CITY OF ALBUQUERQUE

**Re: Country Club Place - Lot 2 - Phase I, 1900 Central Ave SW,
Request for Permanent C.O. –Accepted
Engineer's Stamp dated: 04-05-11, (J13/D011)
Certification dated: 10-03-12**

DRAINAGE AND TRANSPORTATION INFORMATION SHEET
(Rev. 12/05)

CG-101

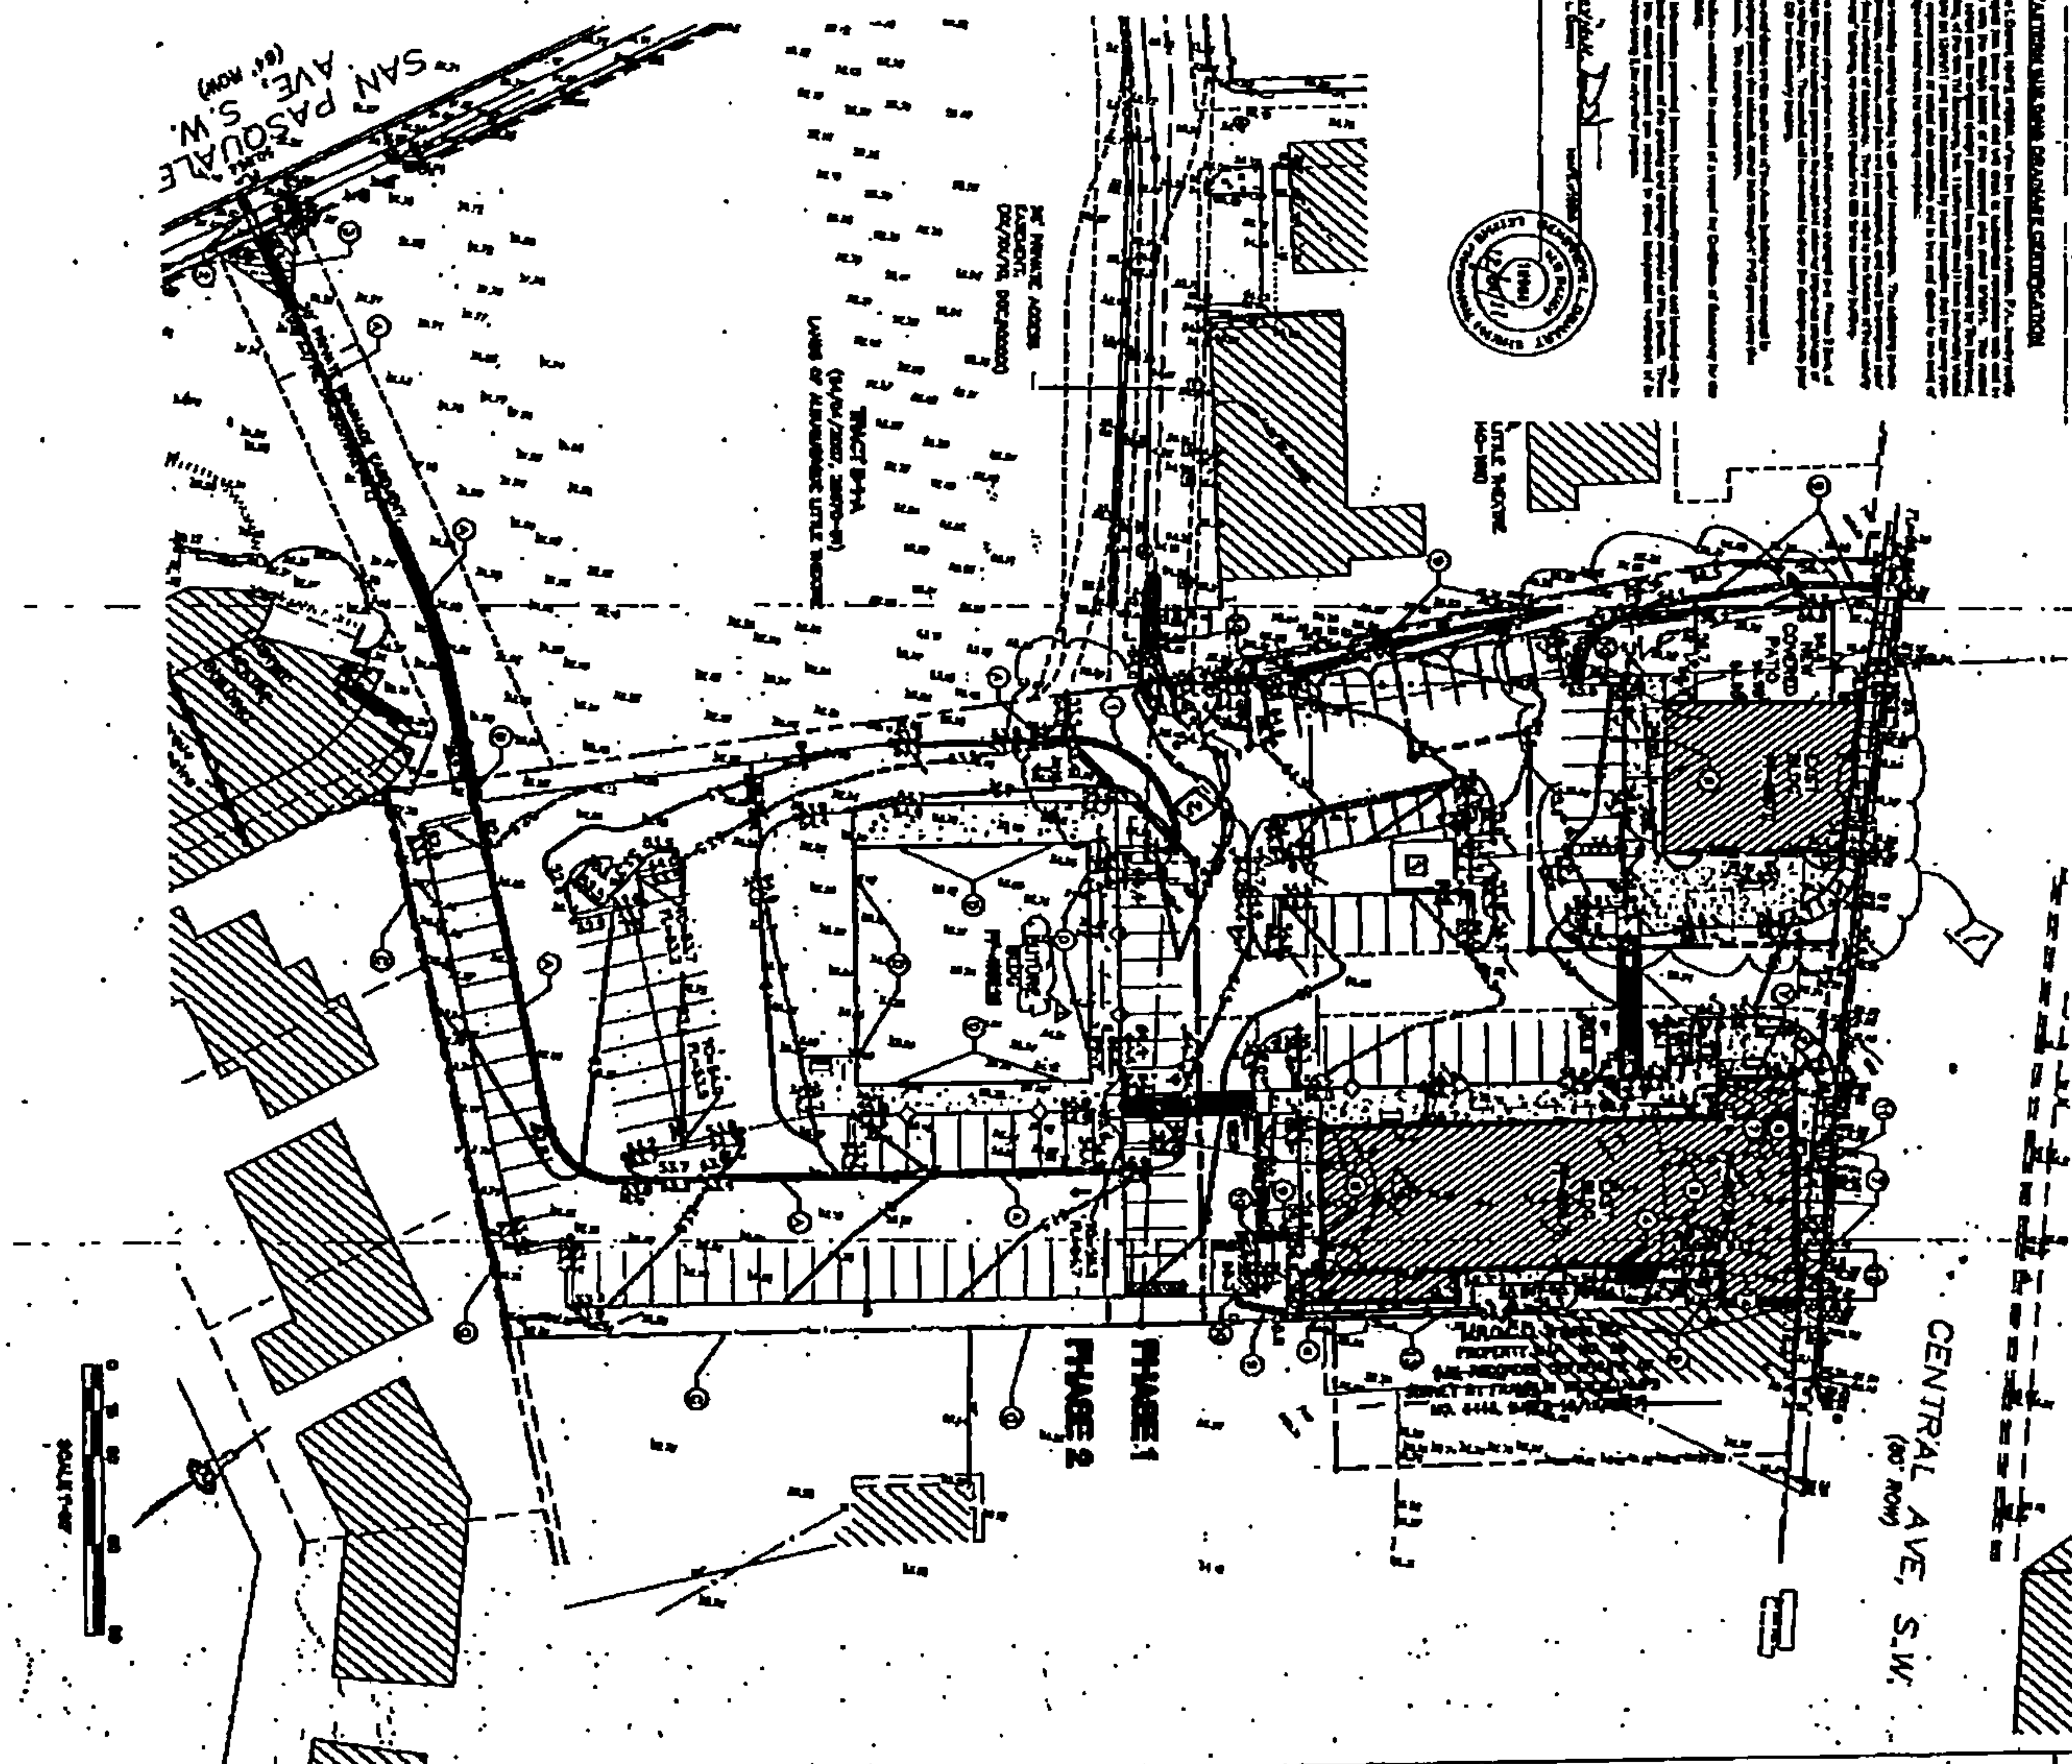
- The drainage addressed in Certification Note 2 is to drain south or an easement and capacity analysis to drain west/not per plan is required.
- Keyed Note 13 is to be changed to what is built or the trench drain is to be built.
- The sidewalk culvert on San Pasquale is to be constructed.
